DOCUMENT CHANGE REQUEST

DCR number 384 Changes required for: General

Title: Transistors Low Power NPN, based on type 2N2857

Number: 5201/014

1.6.1 Metal Can Package (TO-72) - 4 lead

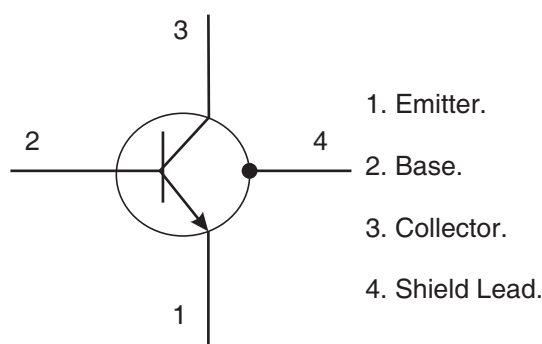
1. Rewording and restructuring of various sections and paragraphs of the specification, plus other editorial changes based on the layout and editorial content of other Detail Specifications already converted to ESCC format.
2. Deletion of redundant paragraphs and information such as Mechanical Requirements.
3. Maximum Ratings table: Remark "Over entire operating temperature range" added for Collector-Base, Collector-Emitter and Emitter-Base voltages.
4. Figure 1 Parameter Derating Information moved to be a note (Note 1) to the Maximum Ratings table.
5. Para. 4.3.2 Weight requirements moved to Component Type Variants table.
6. Figure 2 re-named "Physical Dimensions and Terminal Identification" and revised (drawing and dimensions amended and notes added).

7. Para. 4.2 Deviations from Generic Specification: Deviations revised/re-written per the latest ESCC Generic Specification.
8. Para. 4.4.1 Case requirements corrected to reflect the TO-72 metal can package.
